## **Appendix C – External Roadworks (GTA)**

## DOUGLAS SHIRE COUNCIL INFORMATION REQUEST – 71-85 PORT DOUGLAS ROAD, PORT DOUGLAS

A Development Application has been lodged (reference MCUI2020\_3711/1) with the Douglas Shire Council (Council) for the proposed Fairmont Resort (herein referred to as the 'Resort') located at 71 – 85 Port Douglas Road in Port Douglas. The submission included a Transport Impact Assessment (TIA) report (issue A, dated 3 September 2020) prepared by GTA Consultants.

Council has reviewed the submission and subsequently issued an Information Request (dated 22 January 2021) which includes a number of traffic and transport related items relating to the proposed vehicle access points to Port Douglas Road (Items 2, 3, 4, and 5) and car parking (Items 23 and 24). Responses to the remaining items raised are to be completed by other members of the project team.

Figure 1: All Traffic Turn Left Sign

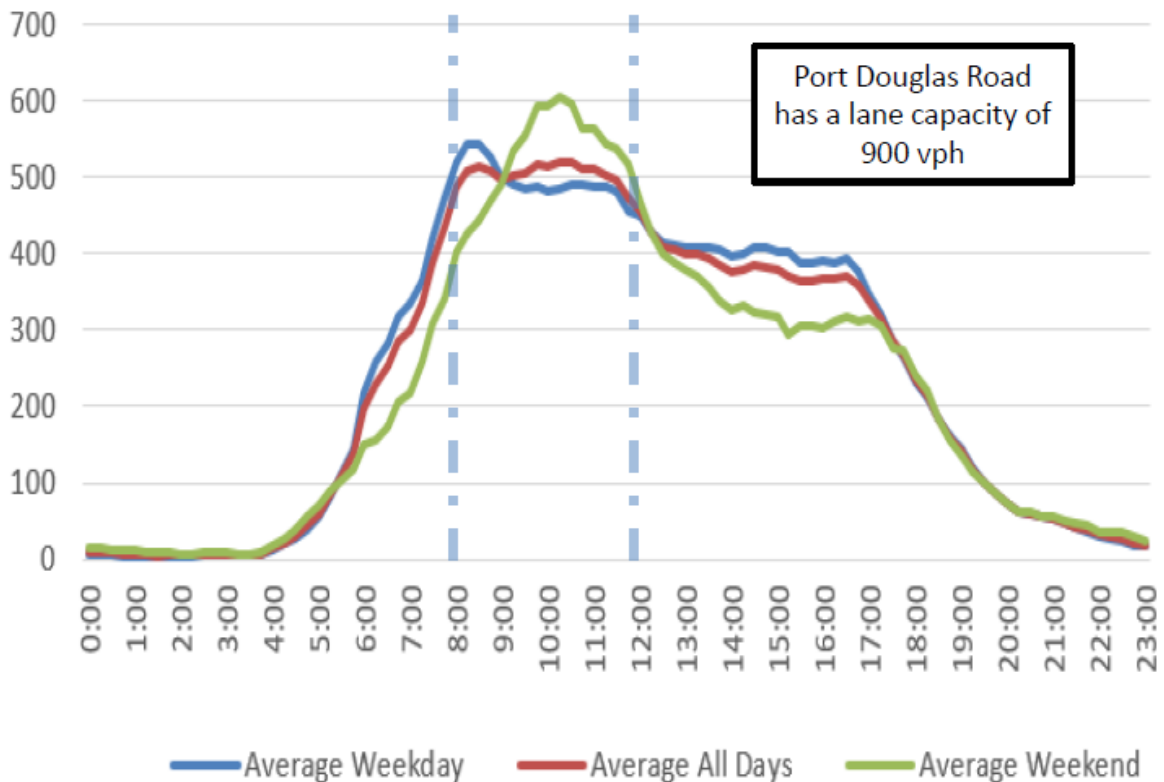
*“Demonstrate that the proposed left-in and left-out of the loading dock is suitably controlled and signed to ensure only these movements will occur.”*

The loading dock vehicle access is to be restricted to left-in and left-out movements only as follows:

- All traffic turn left regulatory signs, as shown in Figure 1
- Painted central median, including double white line, within the Port Douglas Road carriageway
- Entry and exit lane angles designed to reinforce left-in / left-out only restrictions
- Loading dock Traffic Management Plan to control access and egress movements by all couriers and contractors.

Figure 3: Extents of Basement Car Parking Layout Review

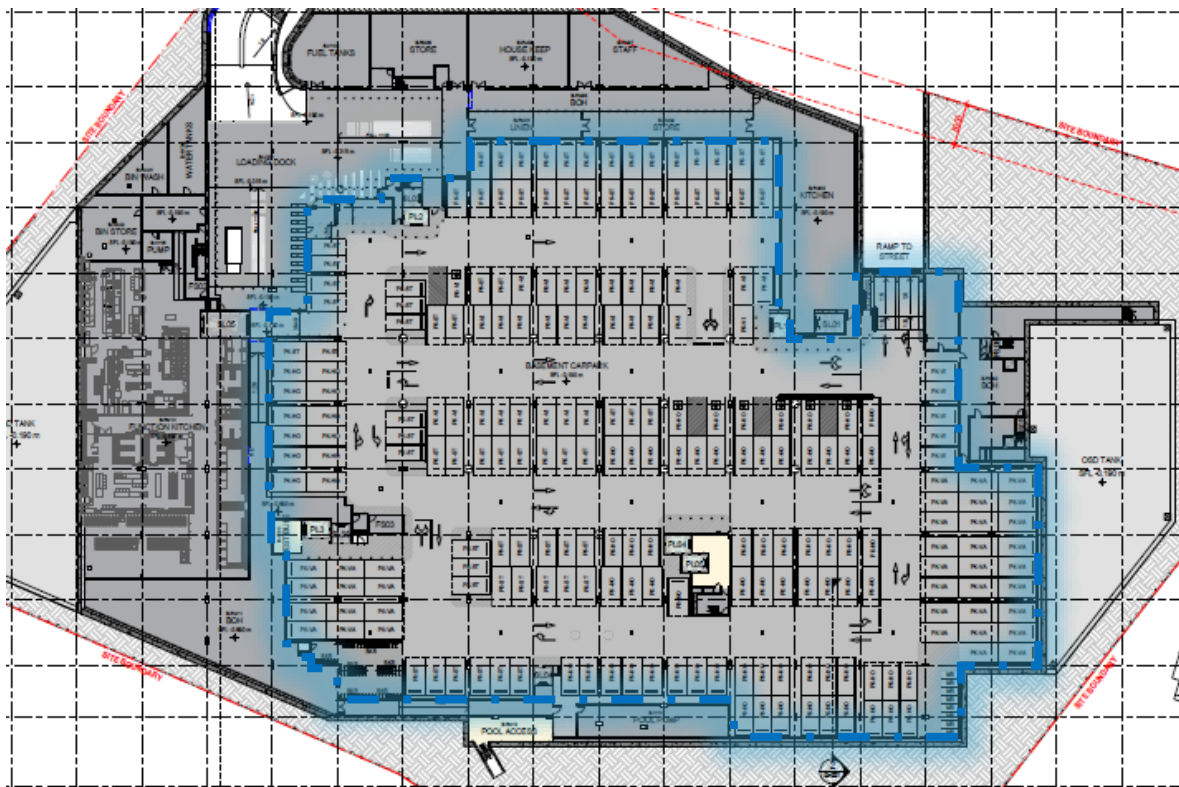
***“Provide a fully dimensioned carpark layout demonstrating compliance with the relevant Standards. The dimensioned plan is to include a statement from an RPEQ to confirm compliance and operation of the parking where tandem or other parking is proposed.”***

A car parking layout review has been undertaken for the proposed basement level car park. The extent of the review is identified in Figure 3 and results of this review are provided in Table 1.

The car parking layout has been designed generally in accordance with the relevant Australian Standards (AS2890.1 and AS2890.6) and is considered to be acceptable.
